# Tice River Homes

## Legacy

model  
40-01

project #  
17052

A0

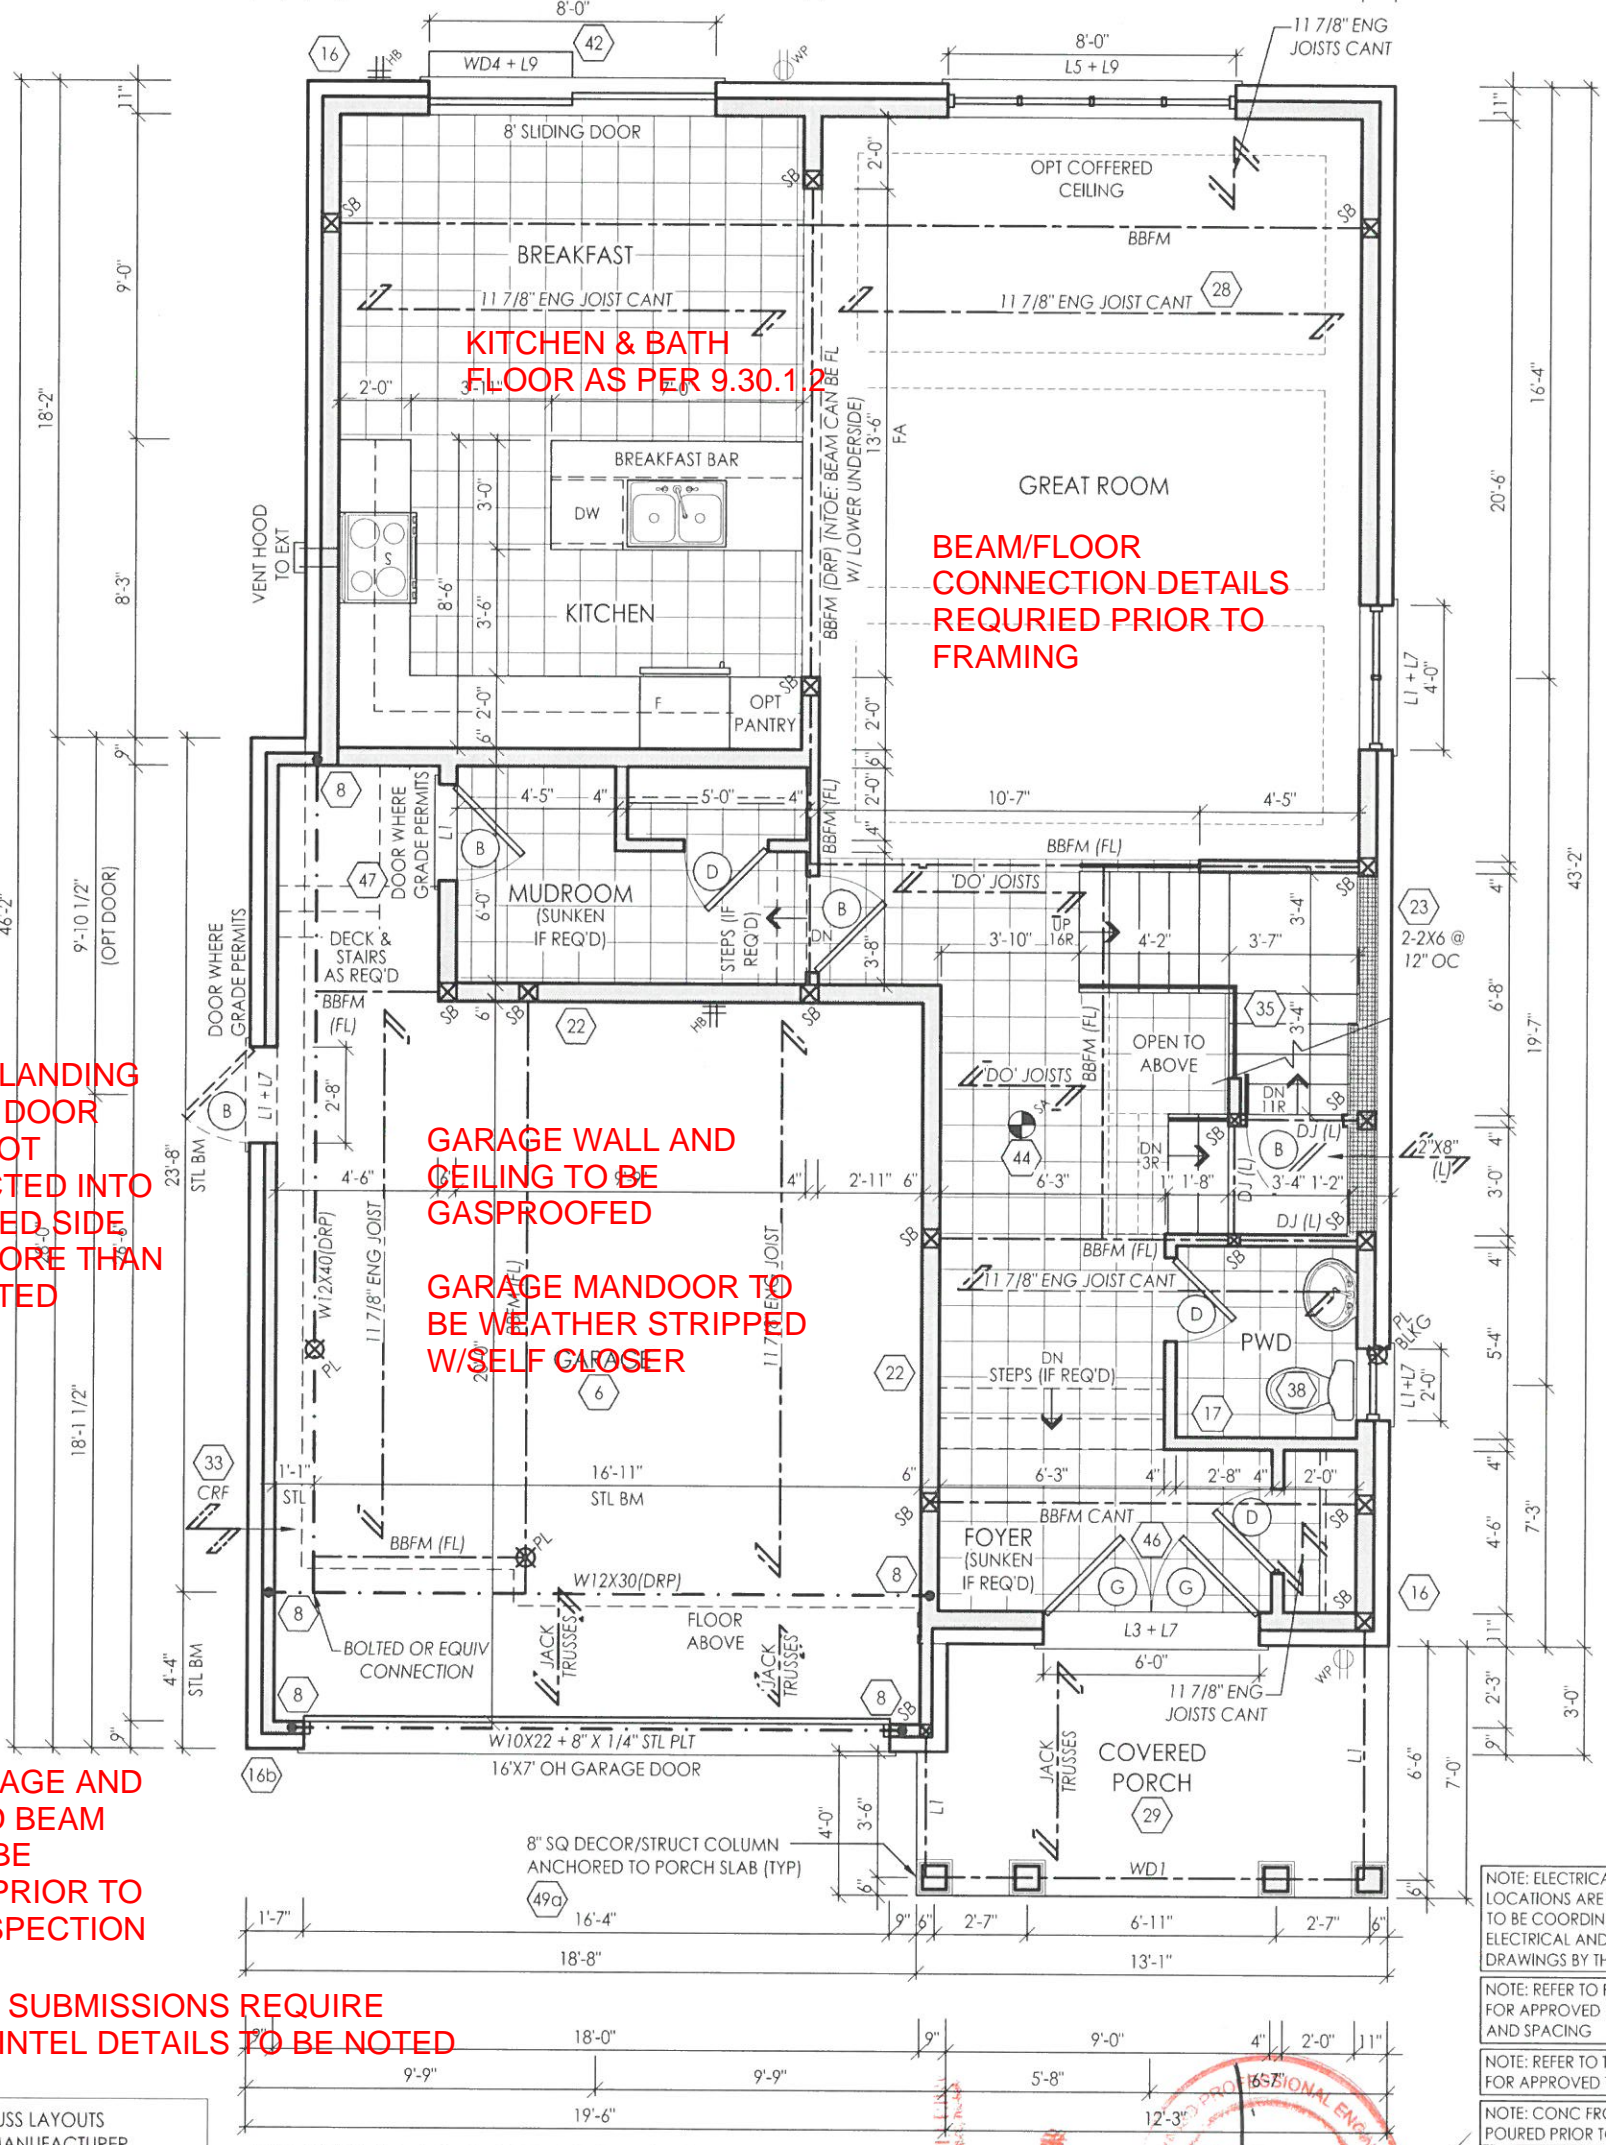
CONTRACTOR RESPONSIBLE FRO ENSURING COPIES OF APPROVED DWGS ON SITE FOR ALL INSPECTIONS

INSPECTIONS TO BE BOOKED VIA EMAIL AT BUILDIGN@NORTHDUMFRIES.CA

GROUND FLOOR ELEV 'A'

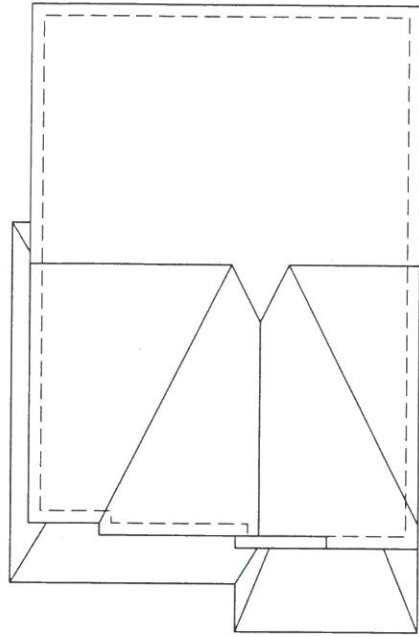
ANY STAIRS/LANDING OUT OF DOOR MUST NOT PROJECTED INTO REQUIRED SIDE YARD MORE THAN PERMITTED

GARAGE WALL AND CEILING TO BE GASPROOFED  
 GARAGE MANDOOR TO BE WEATHER STRIPPED W/SELF CLOSER

LINTEL PACKAGE AND ENGINEERED BEAM DETAILS TO BE SUBMITTED PRIOR TO FRAMING INSPECTION

ALL FUTURE SUBMISSIONS REQUIRE BEAM AND LINTEL DETAILS TO BE NOTED ON DWGS
